Response to Lydian review of Bronozian-Commissioned Reports

Report prepared by:
Blue Minerals Consultancy
Buka Environmental
Clear Coast Consulting

October 2017

Figure 2. Humidity cell test results for eight samples from the Upper and Lower Volcanics.

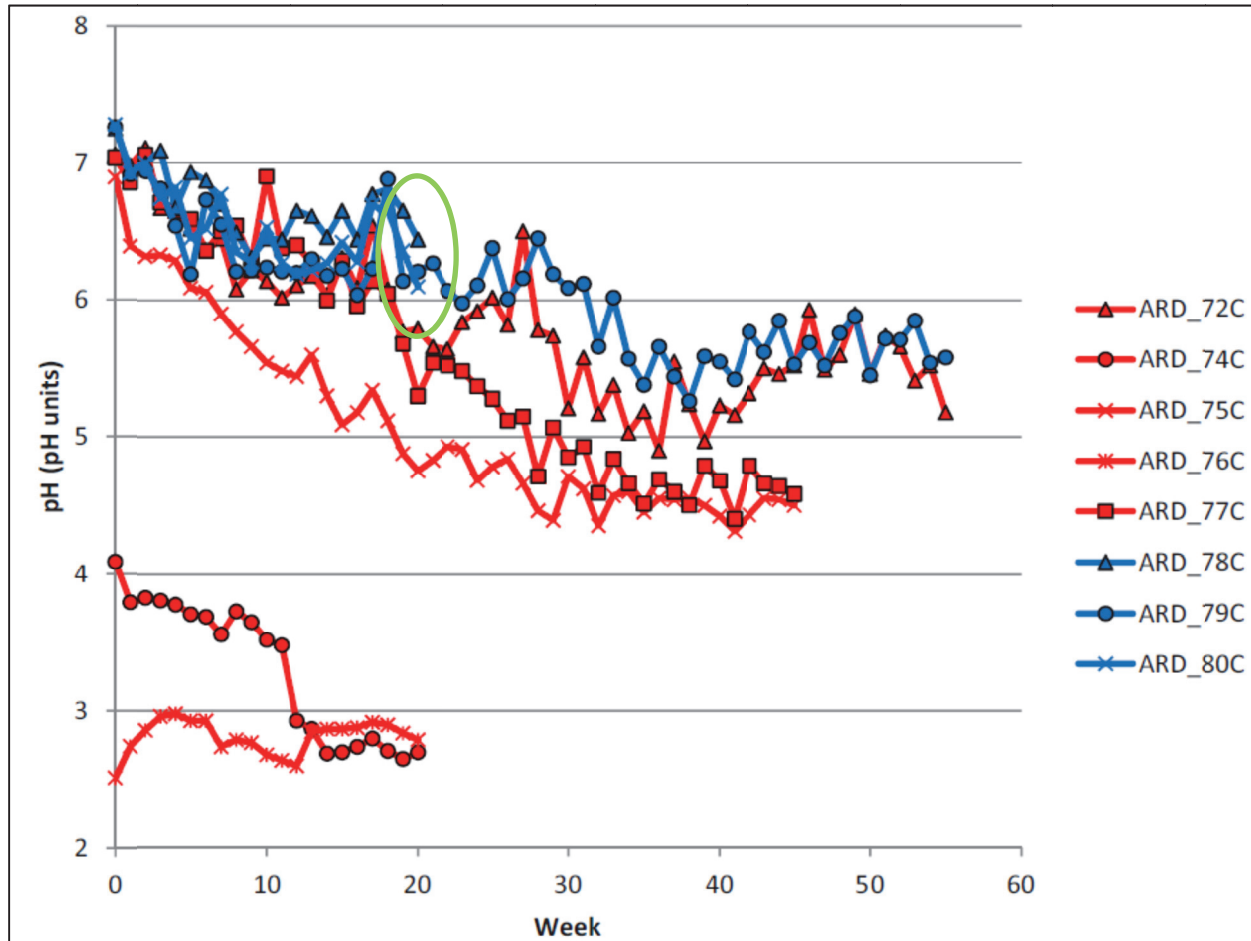
The humidity cell test (HCT) results show that all but two samples produced acid ($\text{pH} < 6$), and the test duration of those two samples was cut short. The HCTs were conducted on materials expected to become waste rock. As shown in Figure 2, all five Lower Volcanic HCT samples produced acid ($\text{pH} < 6$). Only three Upper Volcanic HCT samples were tested. One produced acid after about 30 weeks of testing; the other two samples were cut short at 20 weeks, even though pH values had decreased by about 1 pH unit before testing was prematurely stopped. Additional testing has been committed to and could be under way, but these limited results indicate that the Lower Volcanic material is highly acid generating and the Upper Volcanic material, while likely less acid generating, may nonetheless produce acid as well.

It is stated that "...three of the five LV kinetic cells showed strong resistance to the formation of ferric iron oxidized ARD. These samples produce consistently mild (pH greater than 4.5) ARD, with low sulfate, nearly zero cumulative acidity, and low iron concentrations despite long-duration testing." (Appendix 4.6.2, ESIA 2016). This sentiment is also reiterated in the reply by the reviewers "Ferric iron oxidation has not occurred in old mine waste piles despite the presence of abundant unoxidized sulphides." However, this understanding is based on

- (a) HCT tests 72C, 75C and 77C (see Figure 1) that contained relatively low sulfide S at 0.8, 0.2 and 0.3 wt.%, and
- (b) Historic Soviet waste rock piles also containing low levels of sulfide S of 0.75, 0.2, 0.14, and 0.37 wt.%.

Hence the leach behavior observed reflects the low pyrite content and not any unusual geochemical resistance. In contrast, the mean sulfide S values of the Tig/Art and Erato Lower Volcanic barren rock samples were 1.31 and 0.88 wt.%, respectively.
